Reference: Rio Santa Fe Business Park Preliminary/ Final Plat, Final Development Plan, & Master Plan Amendment

Re: CDRC Case # MPA/PP/FP/FDP 10-5352 Rio Santa Fe Business Park- Master Plan, Preliminary and Final Plat T16N, R8E, Sec 2, 3 and 10.

**TERRAIN MANAGEMENT PLAN
GRADING AND DRAINAGE PLAN**

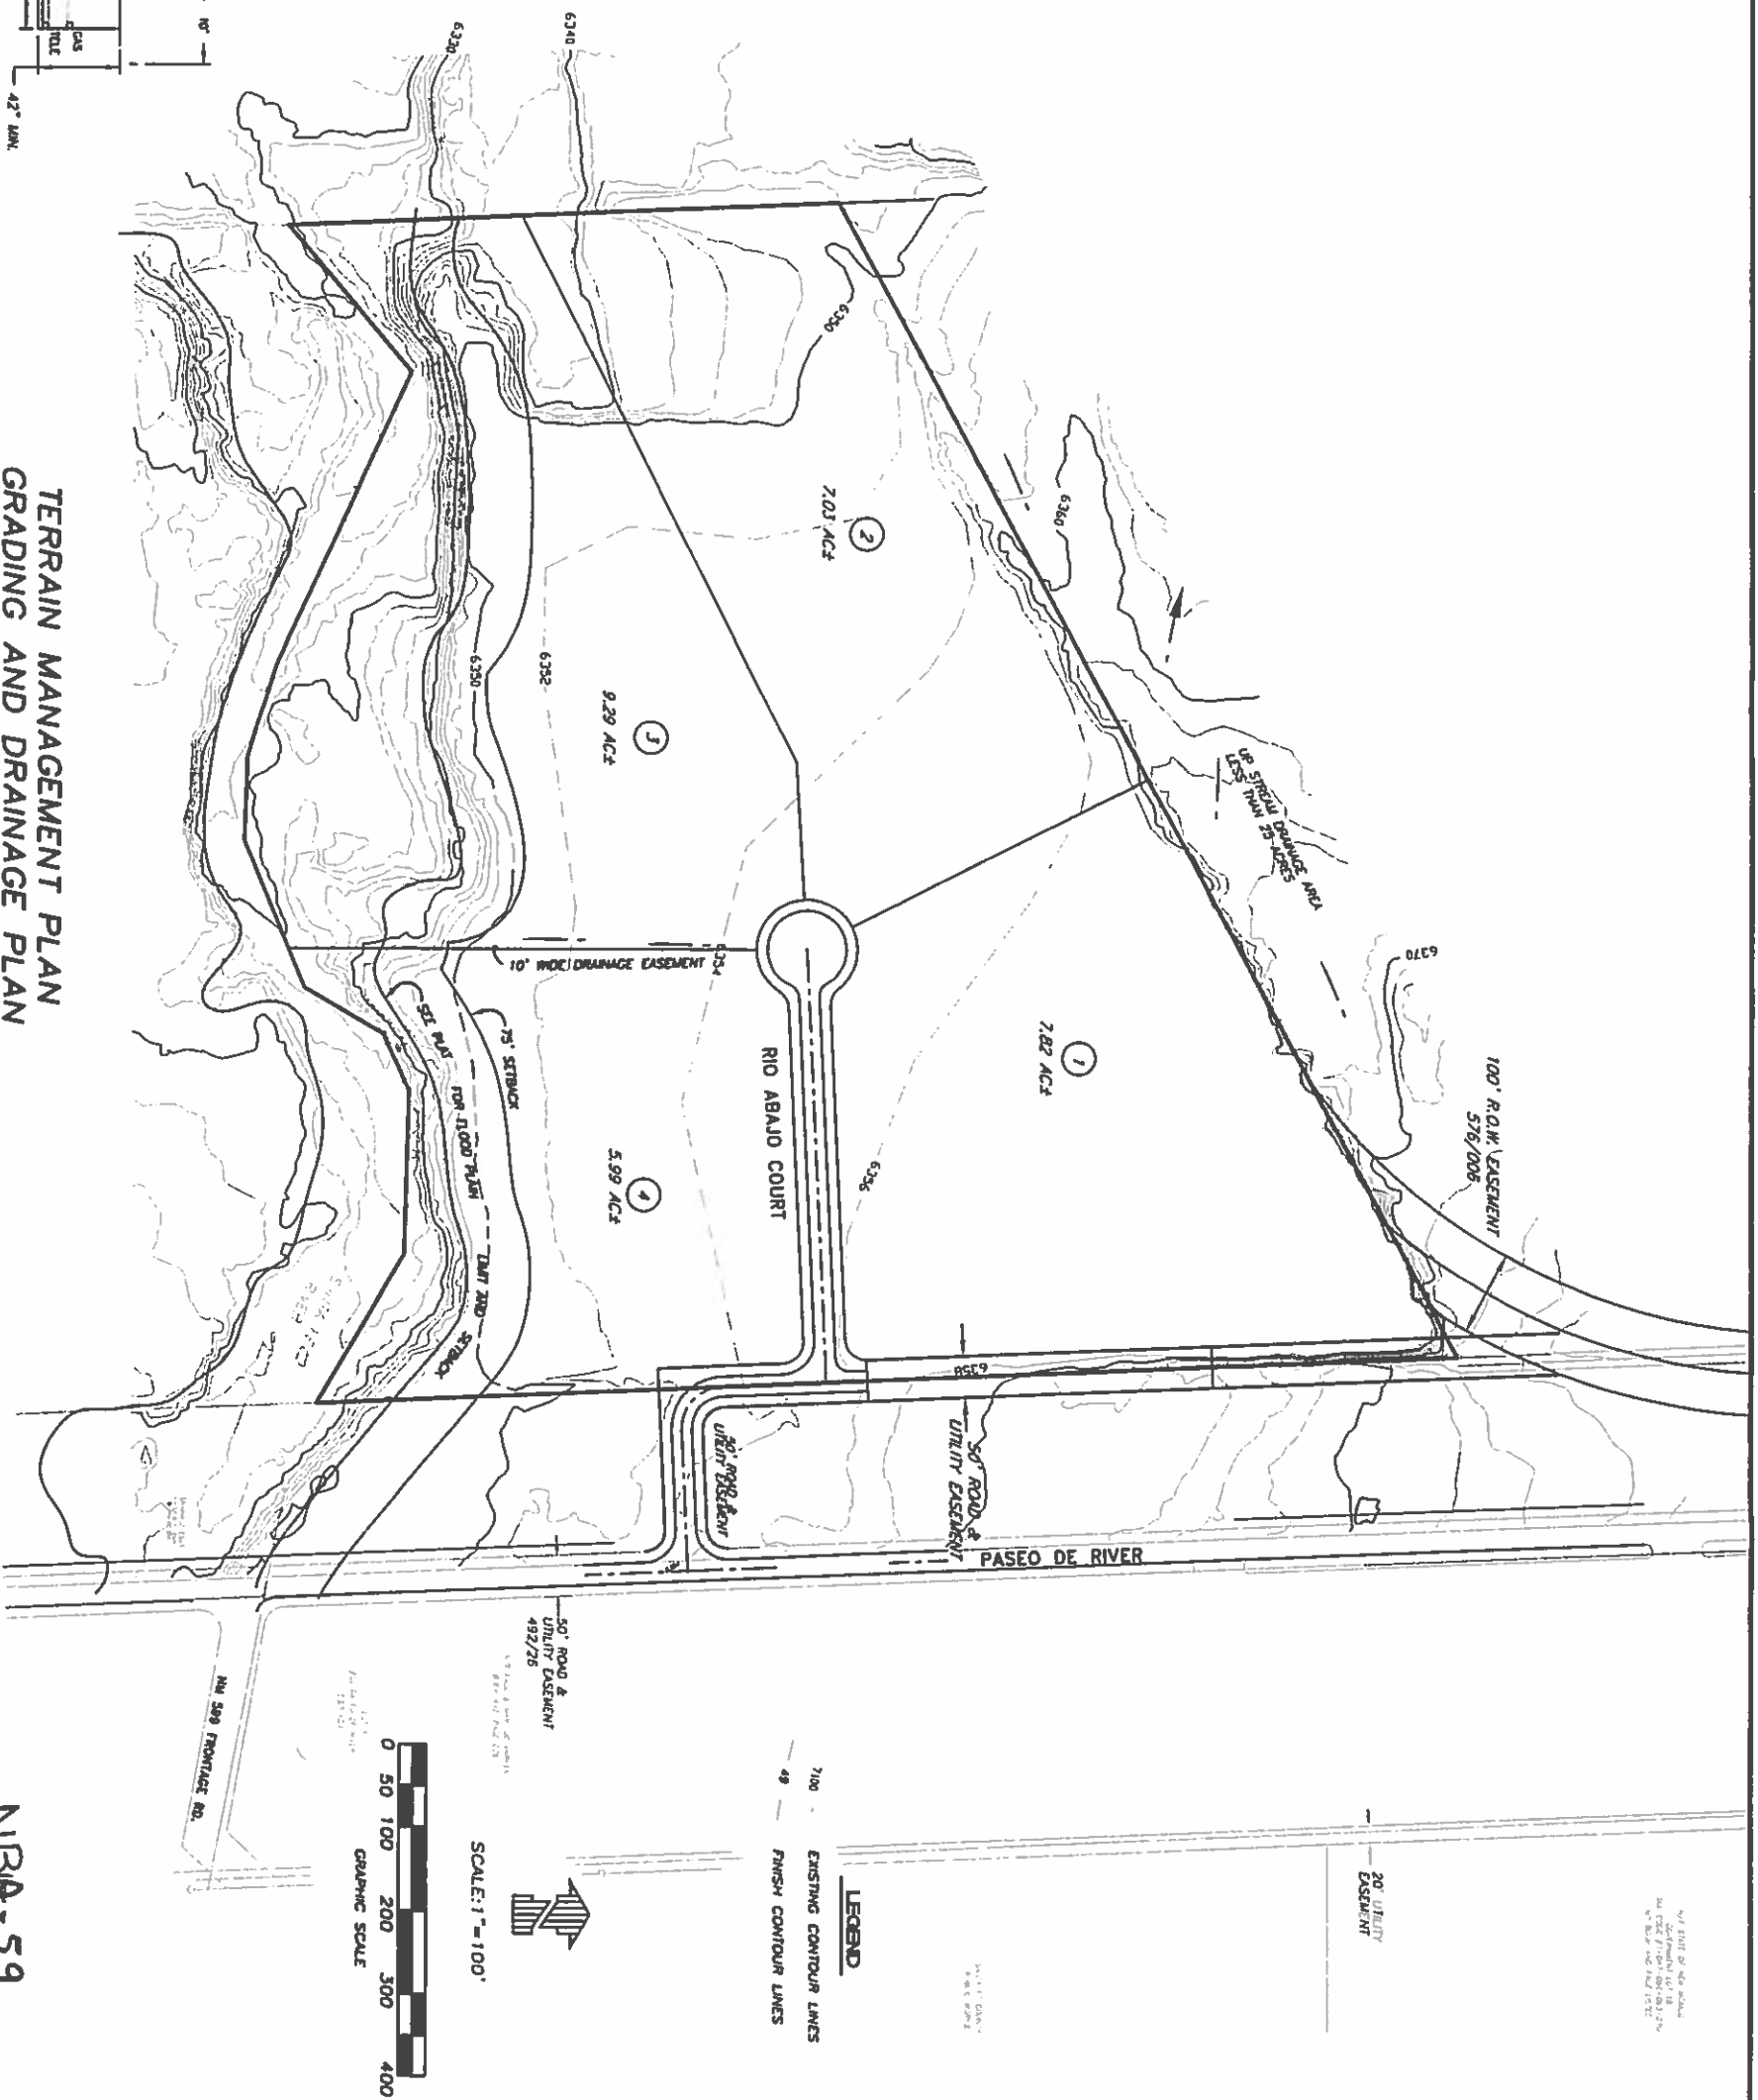
1. Change Item 2 under Notes and Conditions on sheet P-4 to read "Water use is restricted to 0.25 acre-feet per lot per year unless the lot owner prepares a geohydrologic report approved by the County Hydrologist demonstrating water availability as allowed by the code."
2. Include the statement "Submission of a water quality documentation package pursuant to Article VII Section 6.5.1d upon drilling of a well to serve any future development" on the final plat in addition to the disclosure statement.
3. Submission of water restrictive covenants.

JAMES W. SIEBERT AND ASSOCIATES, INC. 610 MONROE STREET • SANTA FE, NEW MEXICO 87501 PH: 505-833-3300 FAX: 505-833-3311		RIO SANTA FE BUSINESS PARK ROAD PLAN AND PROFILE	
DATE: 07/20/14 DRAWN BY: [Signature] CHECKED BY: [Signature]	SCALE: 1" = 50' DATE: FEBRUARY 2014 PROJECT: C-2	NBA-60

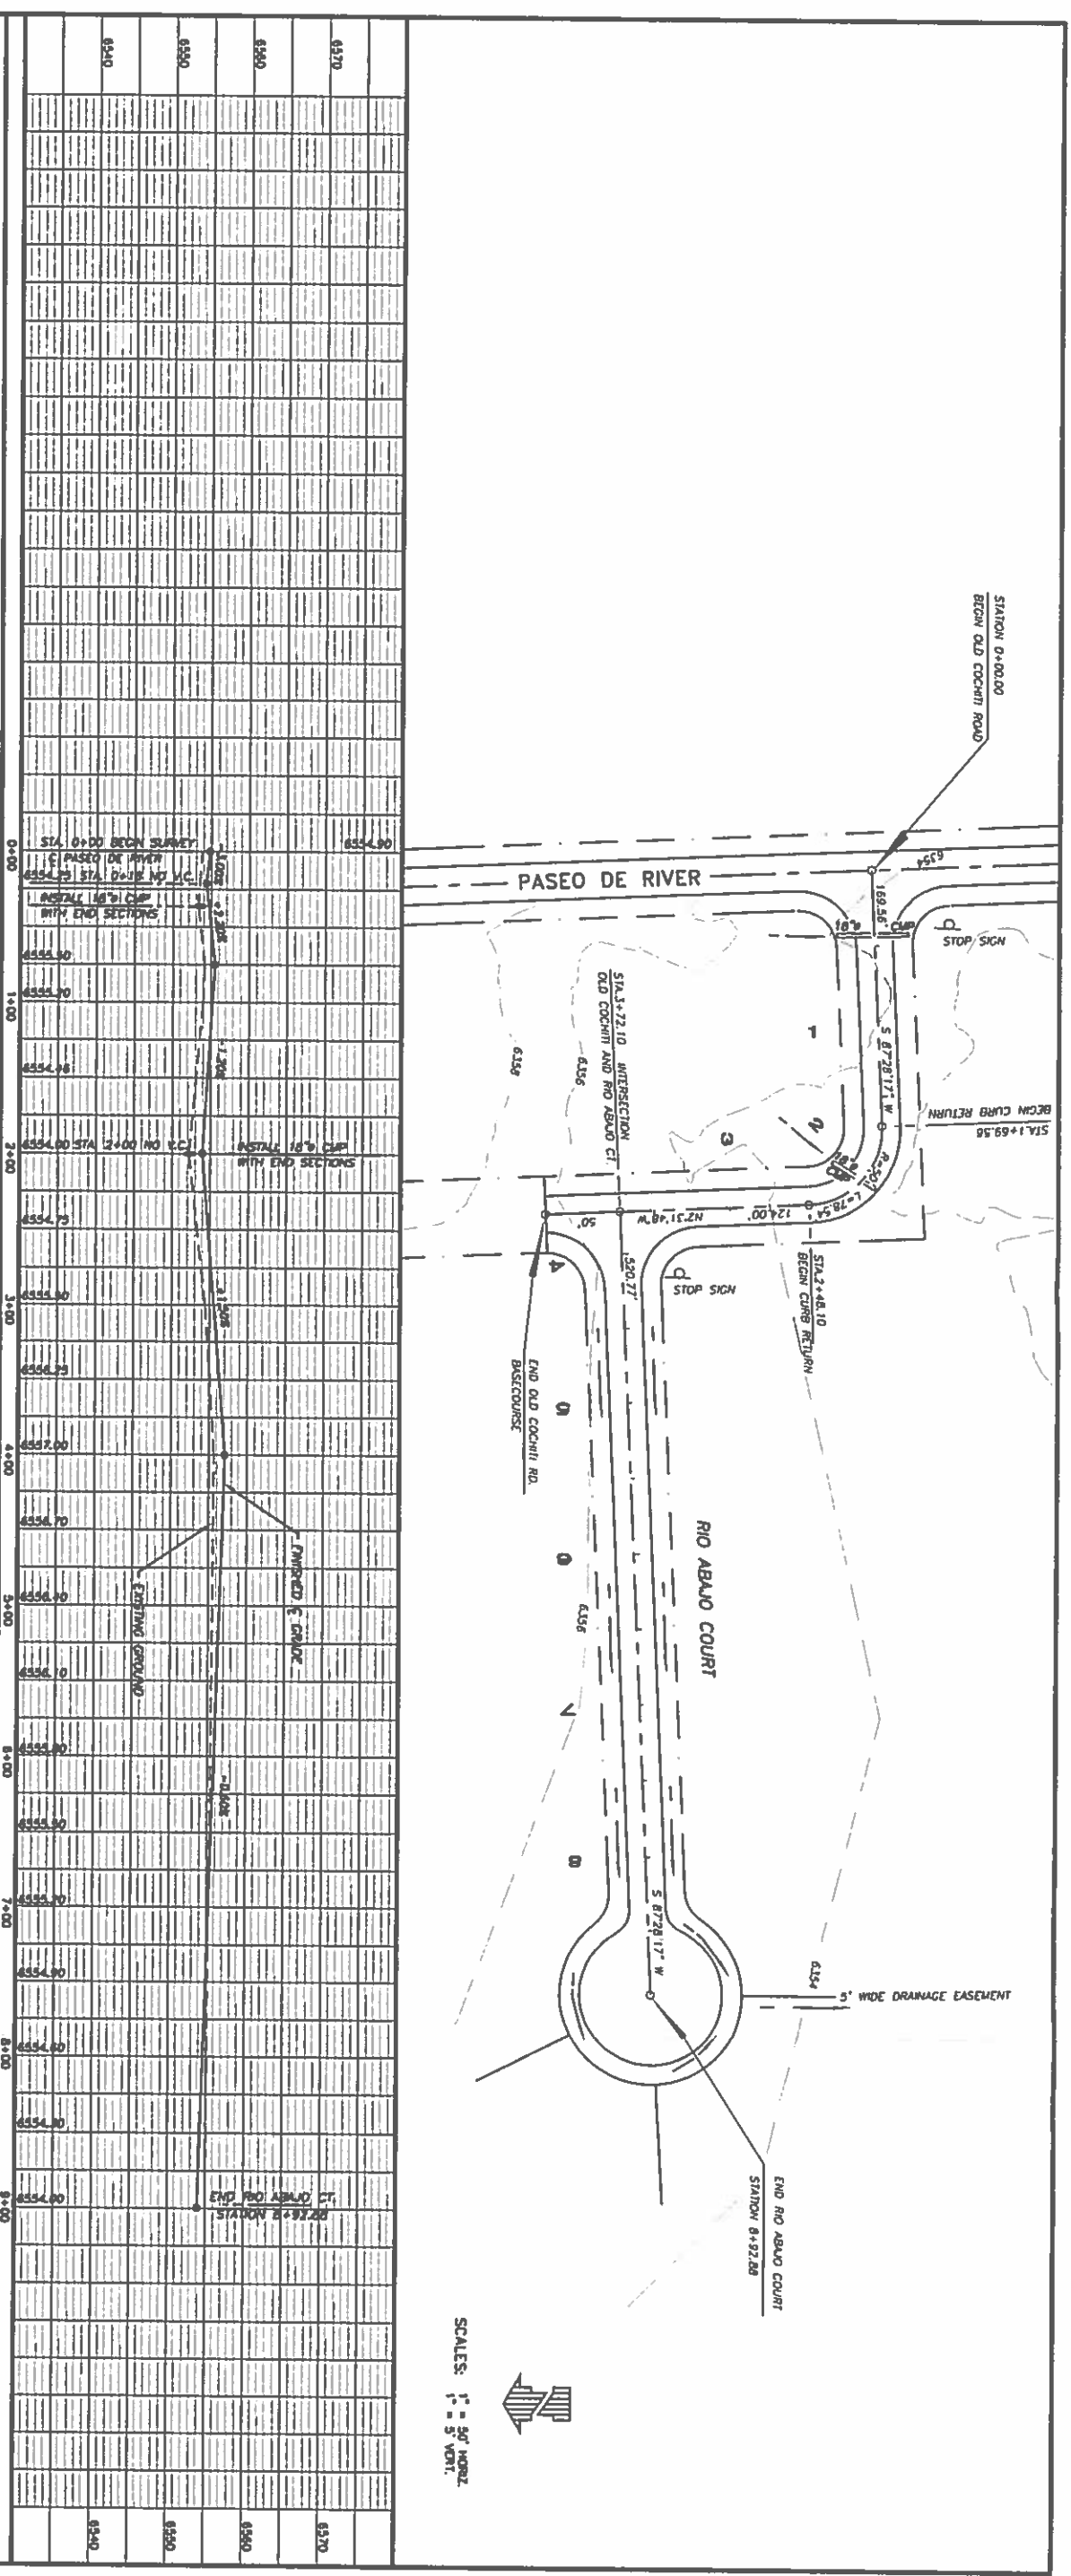
- Staff will require that a Traffic Impact Study will be required for each lot at time of development.
- Sheet C-2 shows that cul-de-sac is in excess of 500' allowed by Article V Section 8.2.1d. of the Land Development Code. Applicant shall submit approvals from Land Use and the Fire Marshal to Public Works to allow cul-de-sac length.

- Applicants Proposed Plat has road labeled RIO ABAJO ROAD, however sheet C-1 & C-2 have it labeled as Old Cochiti Road, applicant shall make plans consist prior to applying for a development permit.
